3.0 DRAWINGS AND DESCRIPTION OF PROPOSED CHANGES

3.2 BUILDING 2 UPPER FLOORS - TWELFTH FLOOR

TOTTENHAM HALE CENTRE ISLAND SITES

PROPOSED L13 FLOOR PLAN

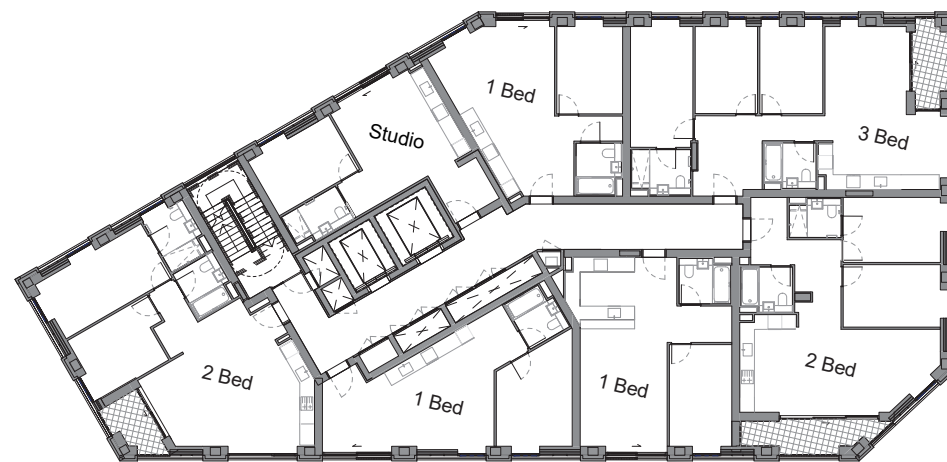
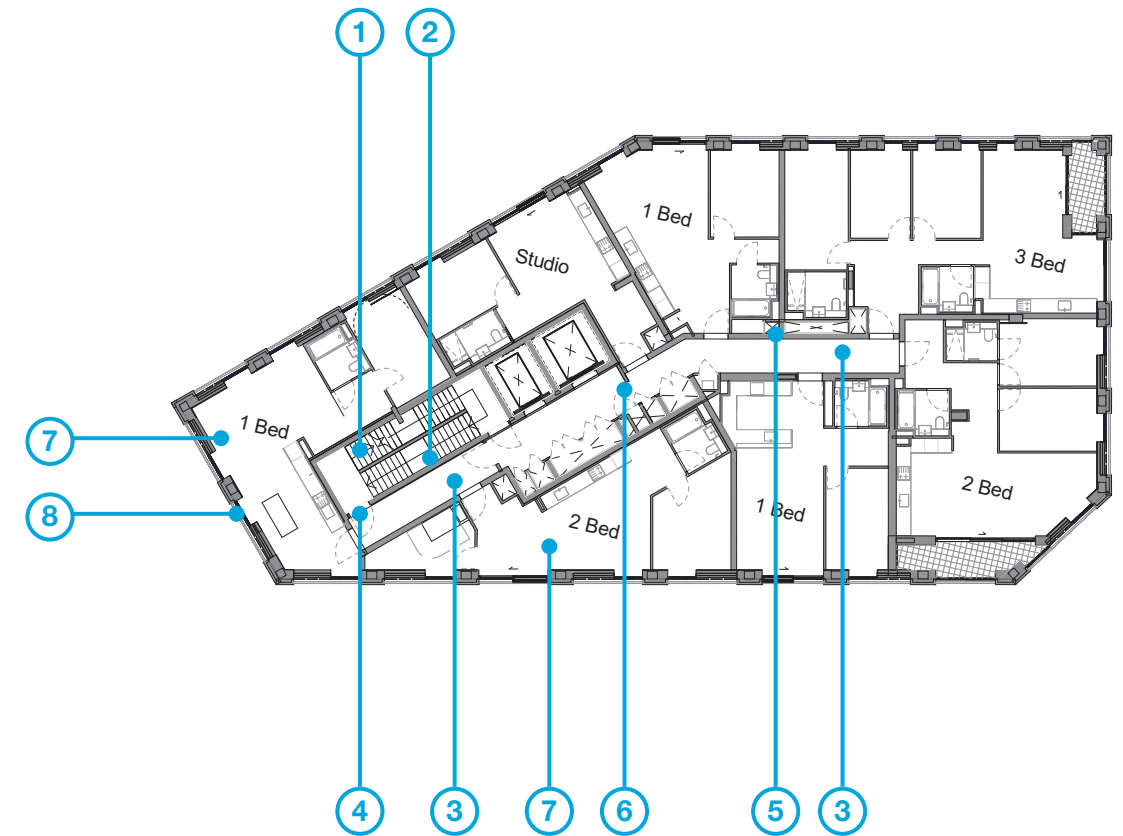
1. The communal stair has rotated through 90degrees to allow a second stair to work in conjunction.
2. A second fire escape stair has been added between ground floor to upper levels.
3. The communal corridor has reduced in width from 2m to 1.5m to accommodate the revised riser layout.
4. Due to the addition of the second stair, the position of the access to the stairs has changed to resolve level changes across all floors.
5. Service risers have been relocated within the core following the addition of the second staircase.
6. Additional doors have been added within the communal corridors to comply with the latest fire strategy.
7. On level 12 the 1 bed and 2 bed apartments have switched location to enable the second stair to be accommodated.
8. Minor amendments to façade around the 1bed

and 2 bed apartment to respond to the updated apartment layouts.
